Access Compliance Report Public Rights-of-Way (Curb Ramps)

Intersection ID: 10041415 Main Street: WESTHALL_DR Cross Street: N/A Location: E

ADA ID: D834E9452250 Ramp Type: PerpDiag Initial Pass/Fail: Fail Overall Compliance: No Severity Score: 12.5

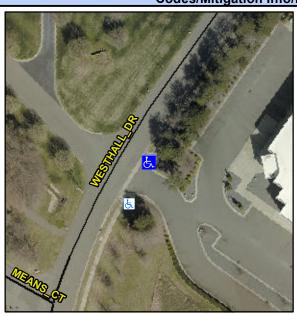
Not Found, R304.5.3

rield Measurements/Component Compilance					
Compliance Description		Data	a Compliance Description		Data
N/A	Ramp Length (in)	108.0	Yes	Ramp Slope (%)	7.4
Yes	Ramp Width (in)	48.0	No	Ramp XSlope (%)	5.4
N/A	Flare Type LT	N/A	N/A	Flare Type RT	N/A
N/A	Flare Slope LT (%)	N/A	N/A	Flare Slope RT (%)	N/A
N/A	Flare Traversable LT?	N/A	N/A	Flare Traversable RT?	N/A
N/A	Landing Length (in)	N/A	N/A	DWS Provided?	N/A
N/A	Landing Width (in)	N/A	N/A	DWS Contrast?	N/A
N/A	Landing Slope (%)	N/A	N/A	DWS Length (in)	N/A
N/A	Landing X Slope (%)	N/A	N/A	DWS Full Width?	N/A
N/A	Landing Curb? (Y/N)	N/A	N/A	DWS Offset (in)	N/A
N/A	Shared Landing?	N/A			
N/A	Gutter Ponding?	N/A	N/A	Gutter Slope (%)	N/A
N/A	Gutter Lip Ht (in)	N/A	N/A	Gutter X Slope (%)	N/A
N/A	Painted X Walk1?	No	N/A	Painted X Walk2?	No
	X Walk 1 Direction	To NW		X Walk 2 Direction	To SW
N/A	X Walk 1 Width (in)	N/A	N/A	X Walk 2 Width (in)	N/A
	X Walk 1 Slope (%)	1.2		X Walk 2 Slope (%)	3.2

X Walk 1 X Slope (%)	2.0		X Walk 2 X Slope (%)	5.4
N/A	Ramp inside XWalk1?	N/A	N/A	Ramp inside XWalk2?	N/A
	Road Slope (%)	4.5	N/A	Clear Space?	N/A
	Road X Slope (%)	5.1	N/A	Clear Space to XWalk (in)	N/A
N/A	Any Obstructions?	N/A	N/A	Storm Grate/Utility Hazard?	N/A
	Obstruction Type		l	Storm Grate/Utility Type

WESTHALL DR None ENTRANCE StopSign Remove & Replace Curb Ramp With Two New Directional Ramps or Equivalent.
